**1.2 409 CLAYTON ROAD, CLAYTON
CONSTRUCTION OF A SEVENTEEN (17) STOREY MIXED USE BUILDING
INCLUDING A REDUCTION IN THE APPLICABLE CAR PARKING REQUIREMENT
(TPA/52295)**

EXECUTIVE SUMMARY:

RESPONSIBLE DIRECTOR:	Peter Panagakos
RESPONSIBLE MANAGER:	Natasha Swan
RESPONSIBLE PLANNER:	Jeanny Lui
WARD:	Oakleigh
PROPERTY ADDRESS:	409 Clayton Road, Clayton
EXISTING LAND USE:	Vacant (former Petrol Station)
PRE-APPLICATION MEETING:	Yes
NUMBER OF OBJECTIONS:	Eleven (11)
ZONING:	Commercial 1 Zone
OVERLAY:	N/A

Figure 1 - Extract of Clayton Activity Centre Built Form Plan

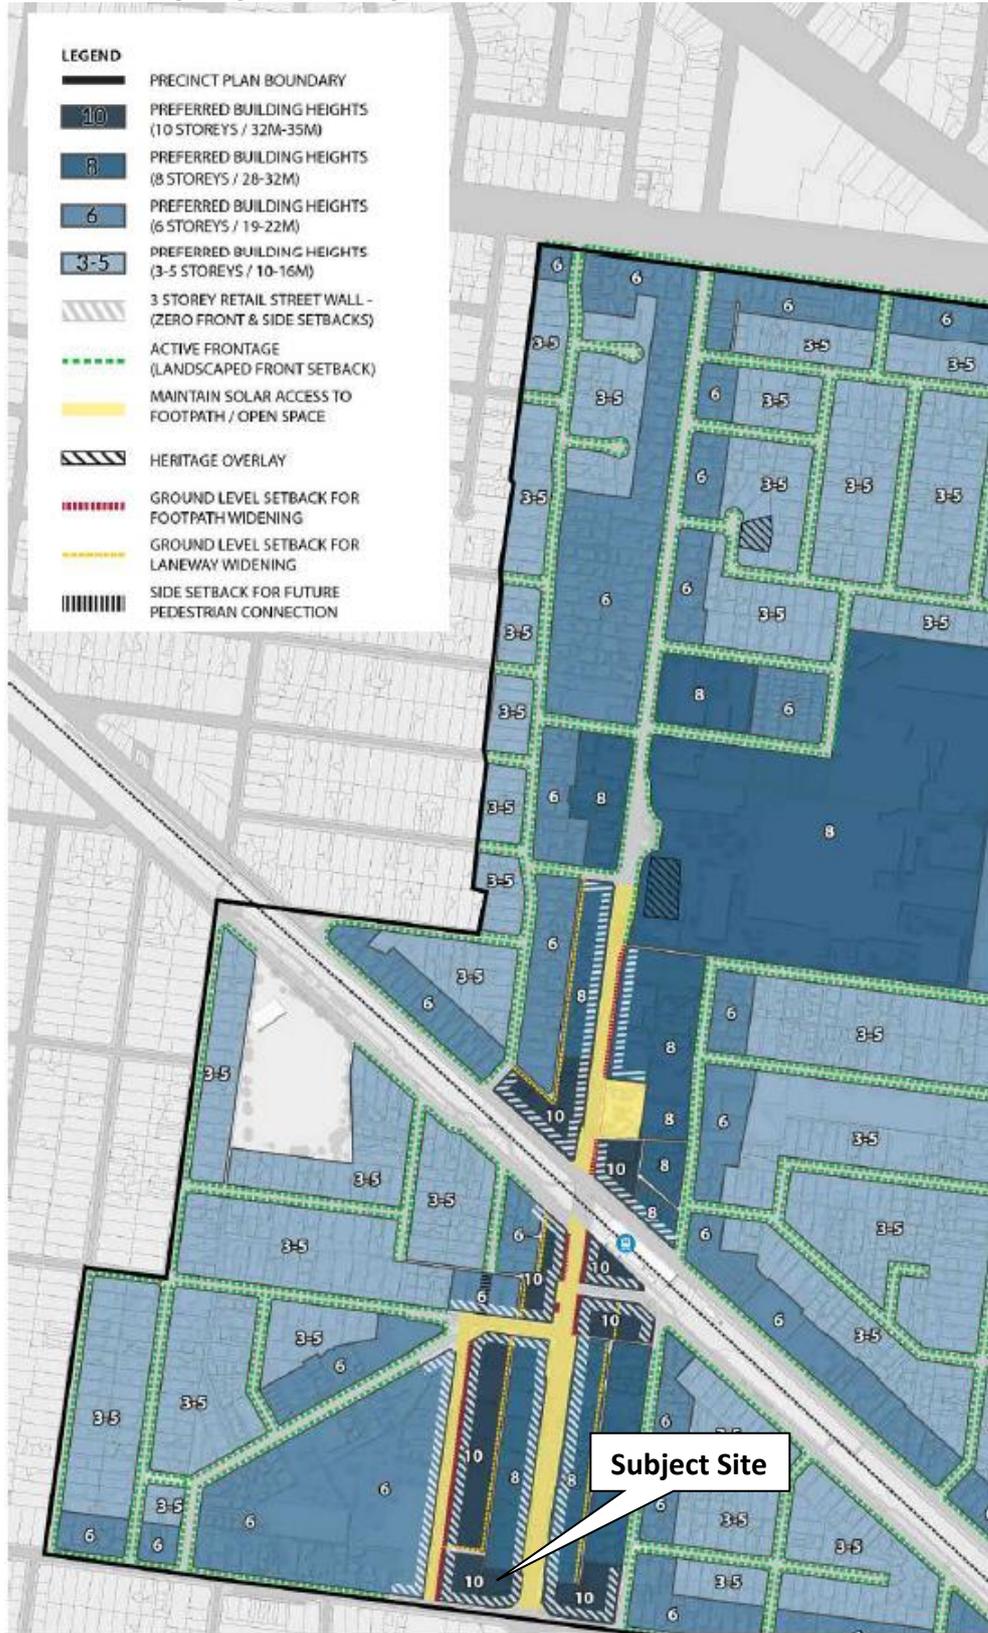
The subject site is located on the southern end of the activity centre, in an area identified for ‘retail/ commercial and mixed use’ (*Figure 8- Clayton Activity Centre Activities and Land Use Plan*). It is within *Precinct 1- Central Retail*, and is identified as a ‘key redevelopment site’ which is suggested to accommodate a greater density of development. This site is earmarked for development with a preferred maximum building height of 10 storey or 32-35 metres, whereas the adjoining properties (not being identified as ‘key redevelopment sites’) are earmarked with preferred building heights of 6 and 8 storeys.

The proposed development with maximum building height of 62.13 metres (17 storeys) significantly exceeds the preferred maximum building height of the Precinct Plan.

The Clayton Activity Centre Precinct Plan envisages buildings within this precinct to have street walls (zero front and side setbacks) up to three storeys (generally 12-13 metres high), with the upper levels setback a minimum of 5 metres from the front boundary.

The proposed development provides a four storey street wall of maximum 20 metres in height, which is at least two storeys (7-8 metres) higher than the preferred street wall height of the Clayton Activity Centre Precinct Plan. This will be further discussed later in the report.

As such, the proposed building height should be substantially reduced to a height more consistent with the outcome envisaged in the Clayton Activity Centre Precinct Plan, as well as having the necessary regard for the suitability of the proposed design response, including the off-site impacts that are created.
